City of Surrey
PLANNING & DEVELOPMENT REPORT

File: 7911-0172-00

Planning Report Date: June 25, 2012

in order to permit the development of a three-storey commercial / office building in City Centre.

GARBAGE ENCLOSURE &
SIGNAGE DETAILS

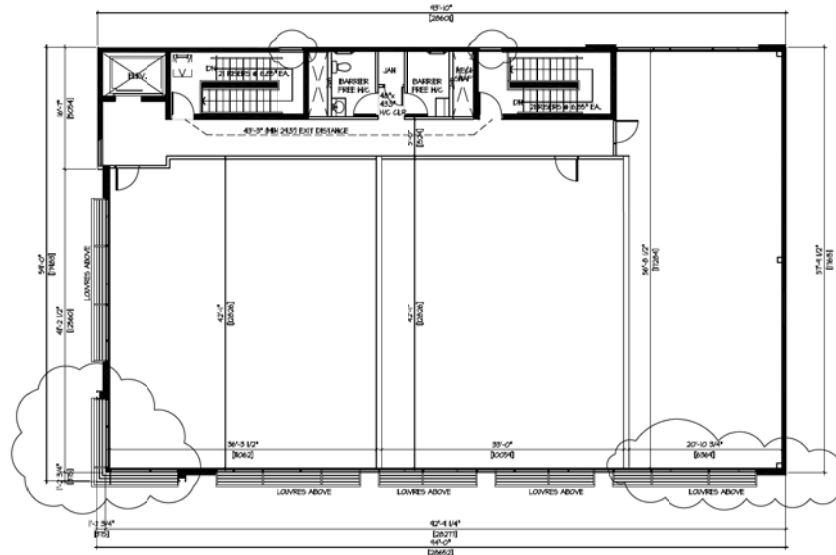
- Integrated signage should be provided. Provide signage concept and details.

(Revised signage has been shown on Drawing AS3.)

DRAWING TITLE:
LANDSCAPE PLAN

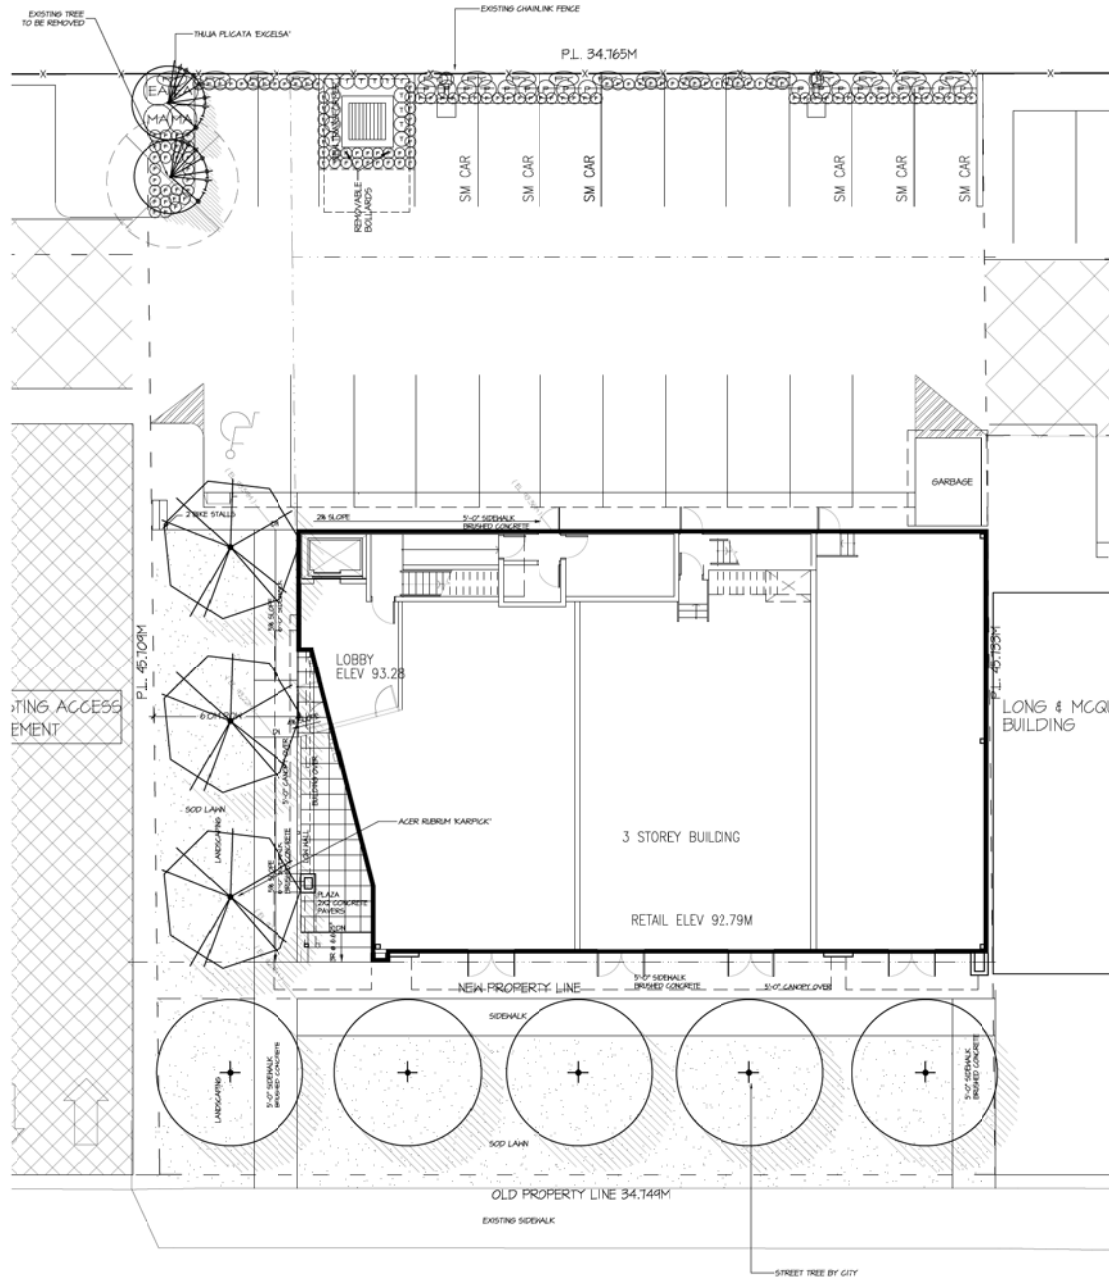
- Given the amount of surface parking, if there are ways to make some of those small car stalls so that trees and shading could be added to the parking area, it would be worth considering.

(The small car stalls have been moved to the other side of the drive aisle to allow for additional planting. Landscaping plan has been updated.)
